Falcon Landing

FALCON LANDING
7344 McLAUGHLIN ROAD
FALCON, CO. 80831

PLOT PLAN LOT 3 BECKETT AT WOODMEN HILLS

PROJECT: BECKETT AT WOODMEN HILLS LOT 3
SHEET TITLE: SITE PLAN
FROM: n/a TO: n/a
JOB NO. 06-0056 SHEET 1 OF 1

TRASH ENCLOSURE DETAIL
N.T.S.

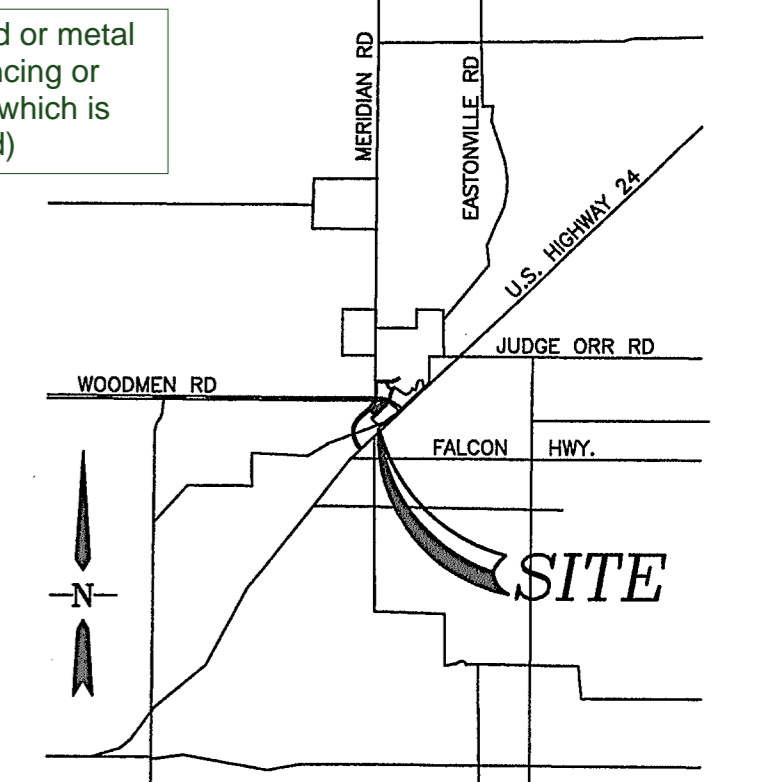
is this wood or metal opaque fencing or chain link (which is not allowed)

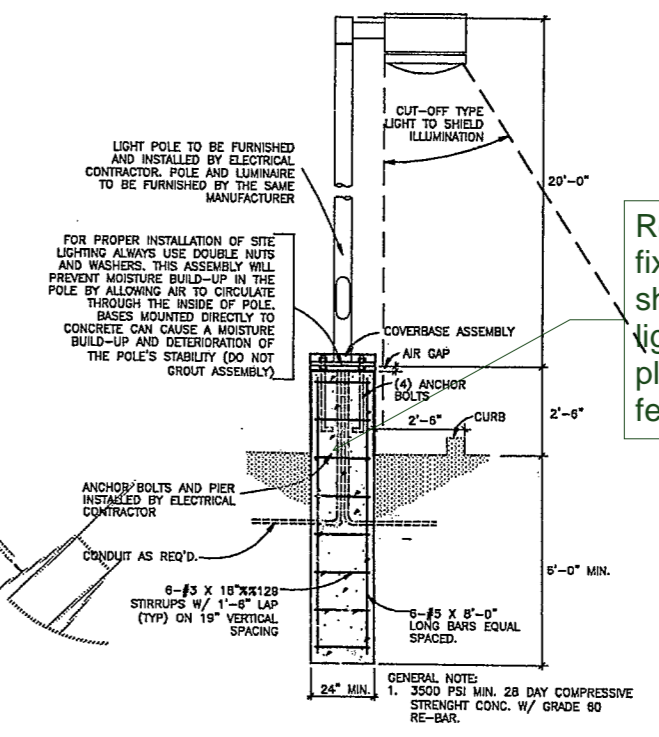
Overhangs as on elevations or wrong elevations?

Elevations show a large warehouse LQ not individual unit or store fronts. Building foot print does not match.

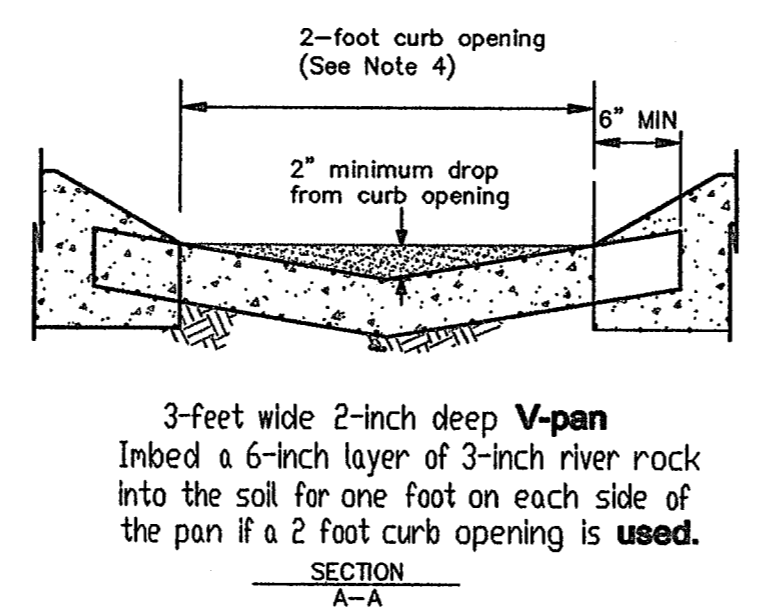
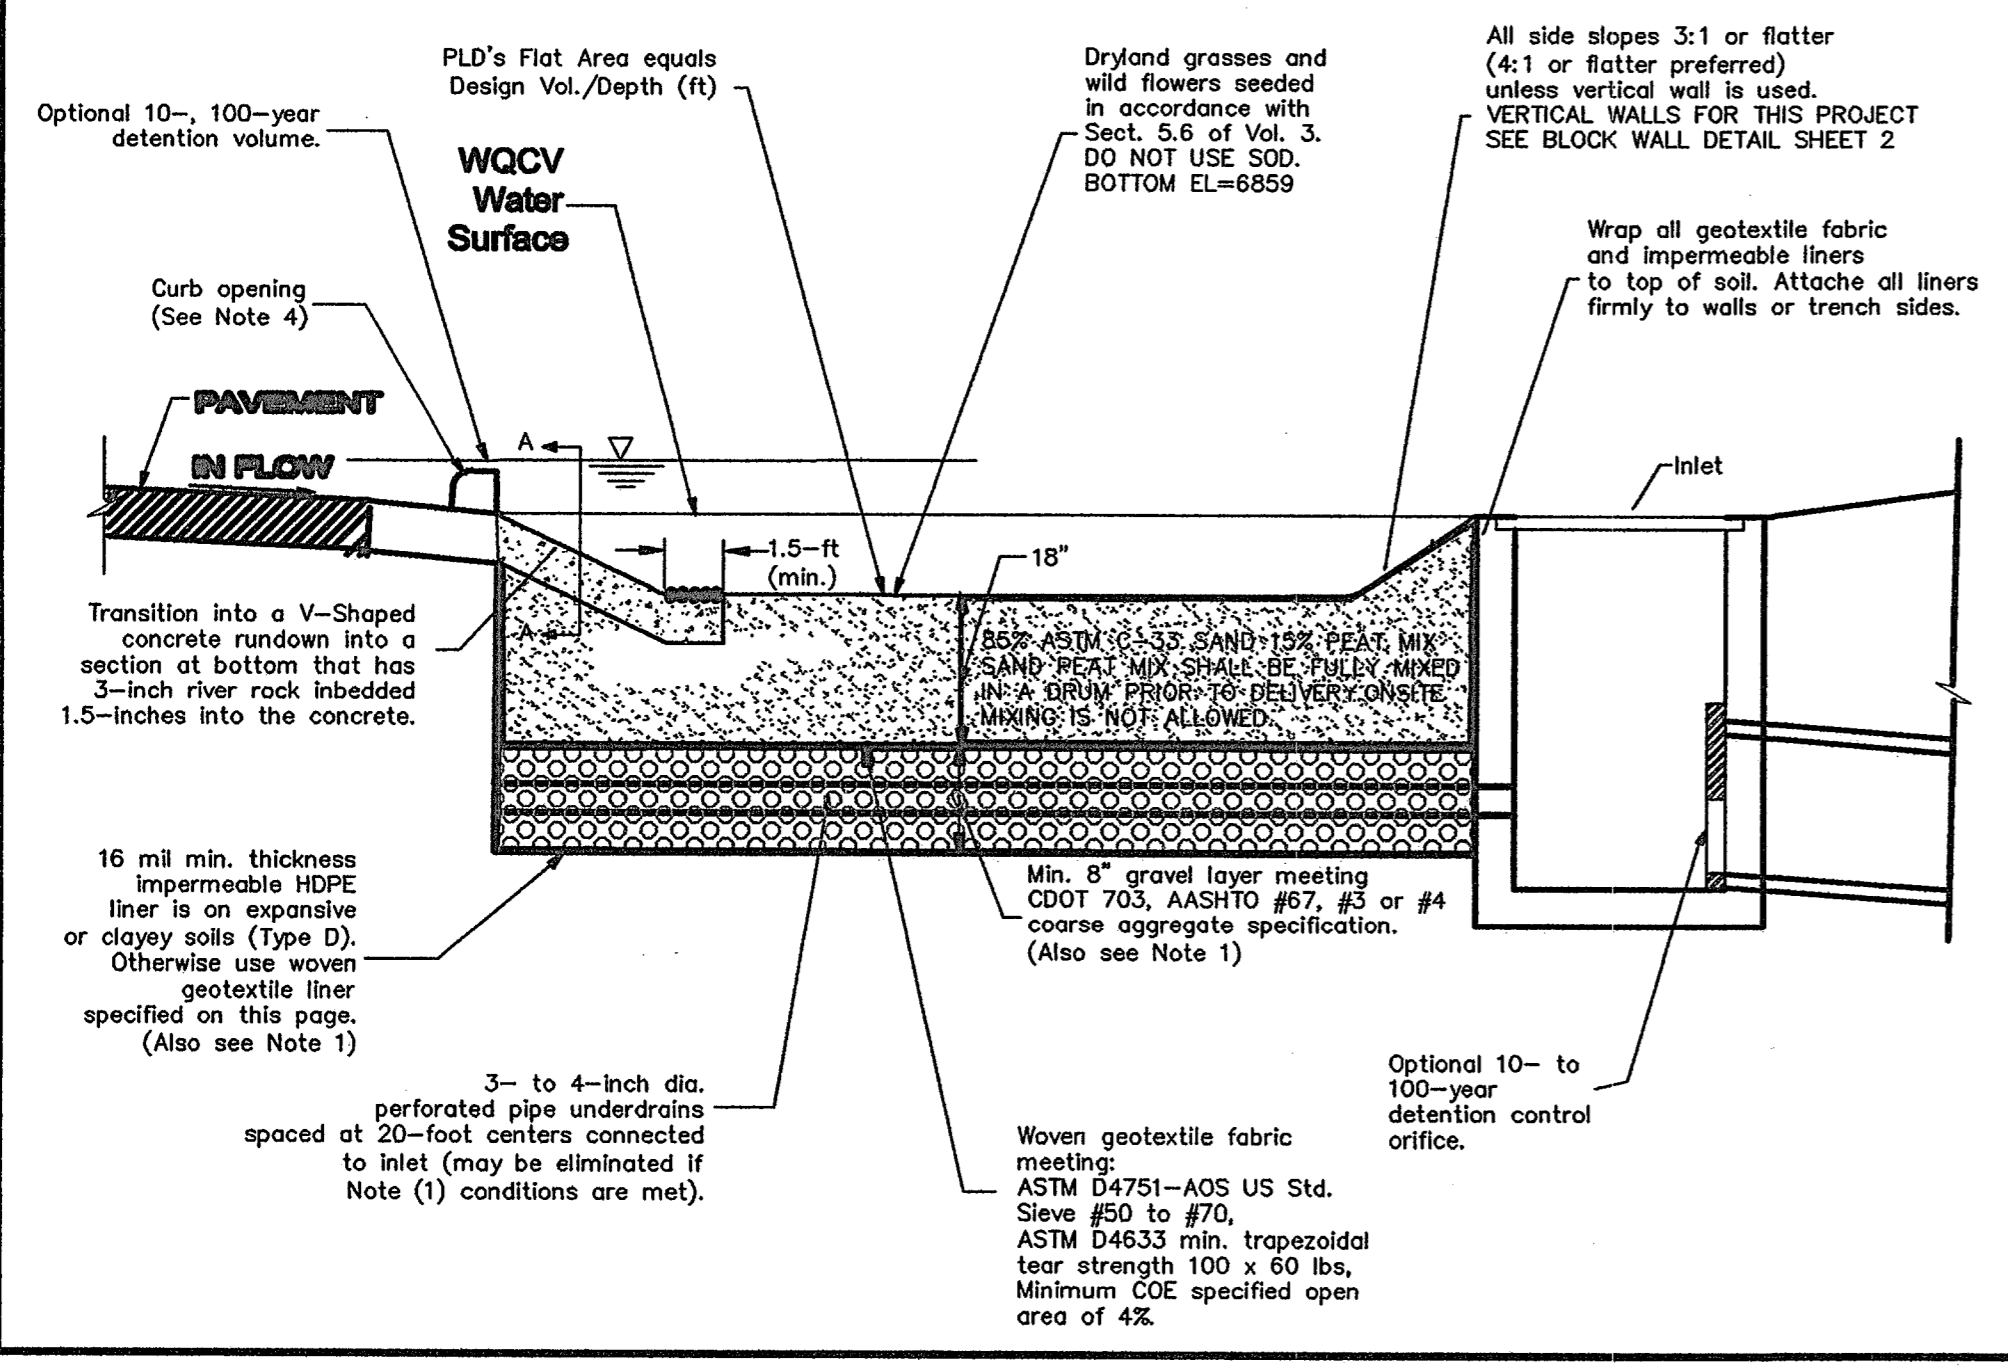
These details are for a sediment basin for construction BMPs. Please clarify this (It is not clear? are you proposing to use the PLD area as a sediment basin during construction?) Also, revise the drawings with elevations for the permanent facility. Currently without this construction BMP Standpipe there is a transition. The permanent PLD does not have an overflow to the inlet as shown in the other details.

Ensure that ADA requirements are met here and throughout site. Provide the std. note on site plan sheet.

Add the following note: Certified percolation tests are required to be submitted to PCD Engineering and written approval from PCD Engineering is required prior to elimination of the Gravel layer, underdrains and geotextile fabric.

STAND PIPE DETAIL
 SCALE: 1"=1'

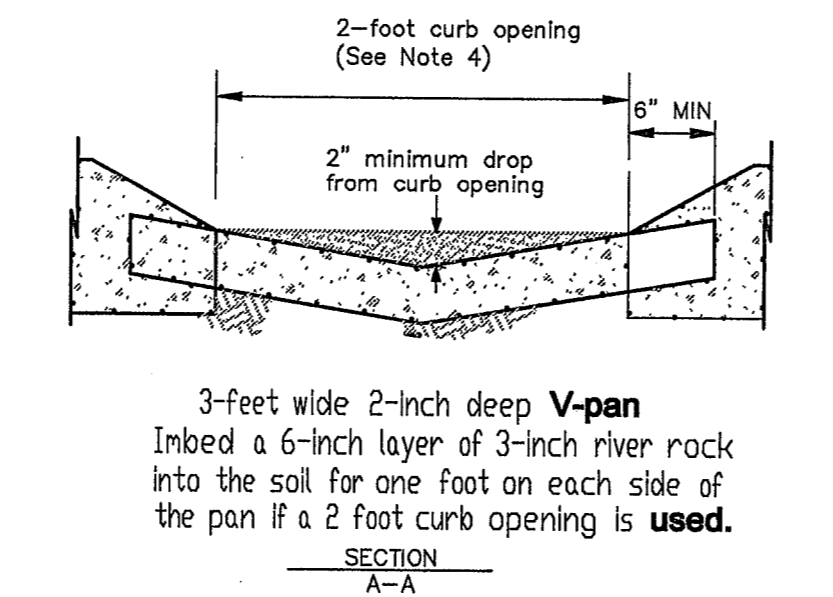
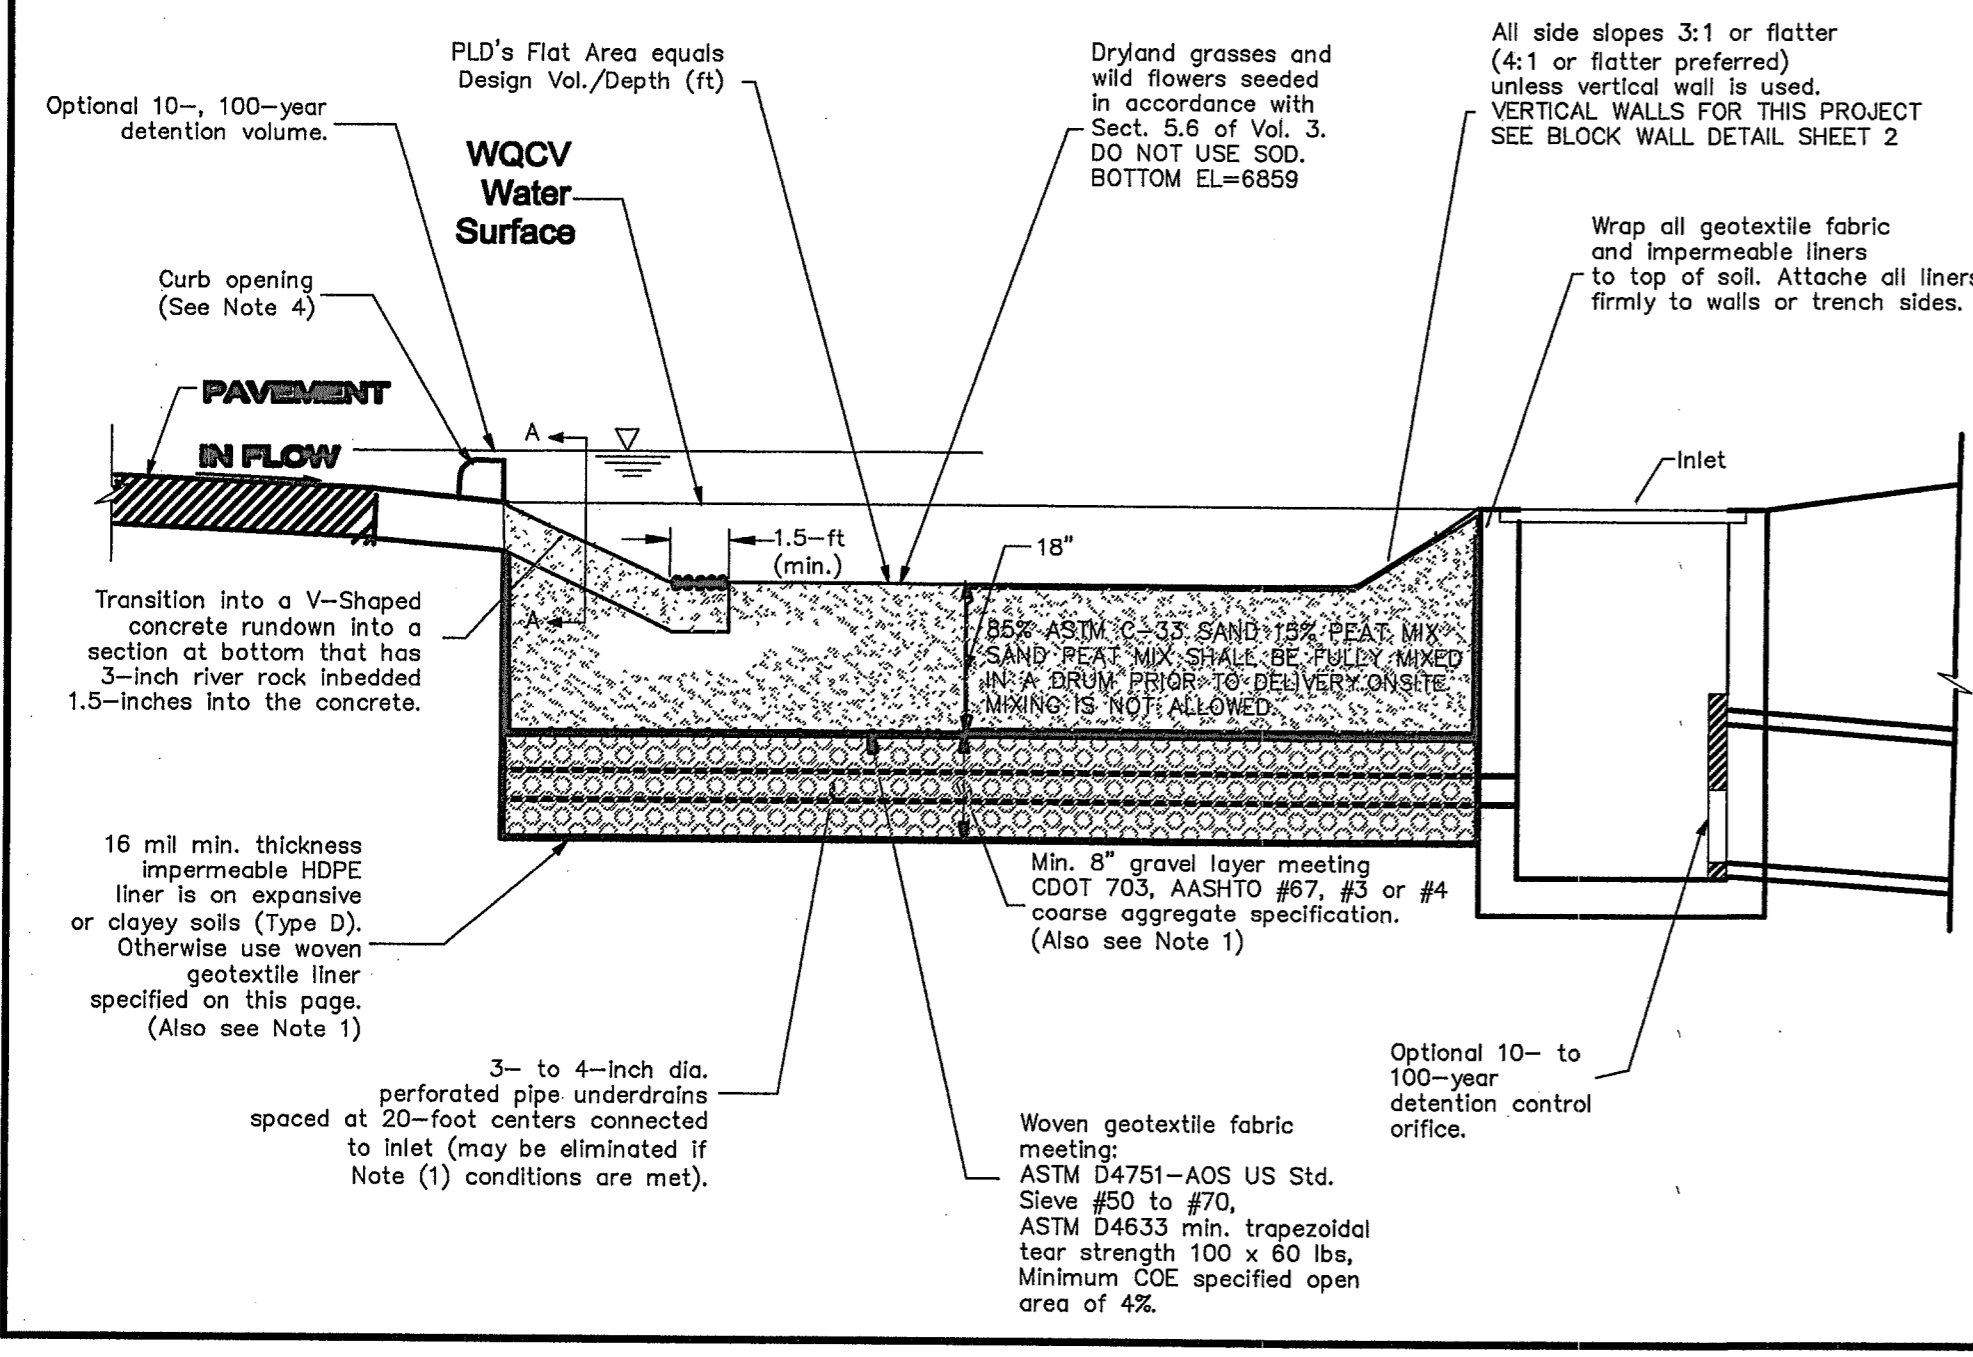
Please have this grading and erosion control plan follow our current criteria and checklist. Note the PCD Engineering comment letter referencing the check list. ECM Section 1.12. New signatures are required. it is noted that sheets 2 of 7 and 3 of 8 are nearly identical? Please revise the site plan submittal as necessary.
